CORPORATION OF THE TOWNSHIP OF ESQUIMALT

Title: Development Variance Permit & Development Permit – 856 & 858 Esquimalt Road, Staff Report No.: DEV-22-091

Report No. DEV-22-091

Development Variance Permit & Development Permit - 856 & 858 Esquimalt Road

Figure 1.

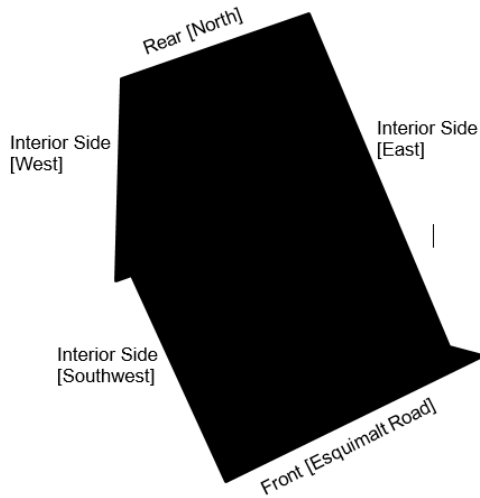
There is a right-of-way proposed along the Esquimalt Road frontage to provide an enhanced public realm in perpetuity. The proposed buildings have considerably different shape and situation on the site than the original proposal intended by CD-80 therefore, the DVP requirements will replace the Section (8) Siting Requirements section with the following:

Within this CD-80 Zone, lot lines and setbacks shall be determined in accordance with Figure 1 (below).

(a) Principal Buildings

(i) No Building shall be located within 7.1 metres of the Front [Esquimalt Road] Lot Line.

(ii) The northwest wing of the southern Principal Building [Building A] shall not be located within 4.3 metres of the Interior Side [West] Lot Line.

(iii) The southwest corner of the southern Principal Building [Building A] shall not be located within 3.1 metres of the Interior Side [Southwest] Lot Line.

(iv) The western wing of the southern Principal Building [Building A] shall not be located within 11.9 metres of the Interior Side [East] Lot Line.

(v) No Building shall be located within 7.5 metres of the Rear [North] Lot Line.

(vi) The northern Principal Building [Building B] shall not be located within 7.7 metres of the Interior Side [East] Lot Line.

(vii) The northern Principal Building [Building B] shall not be located within 6.4 metres of the Interior Side [West] Lot Line.

(viii) The separation between the east wing of the southern Principal Building [Building A] and the south wing of the northern Principal Building [Building B] shall not be less than 17.5 metres.

(ix) The separation between the northwest wing of the southern Principal Building [Building A] and the west wing of the northern Principal Building [Building B] shall not be less than 12.5 metres.

(x) The separation between the northwestern wing of the southern Principal Building [Building A] and the south wing of the northern Principal Building [Building B] shall not be less than 20.0 metres.
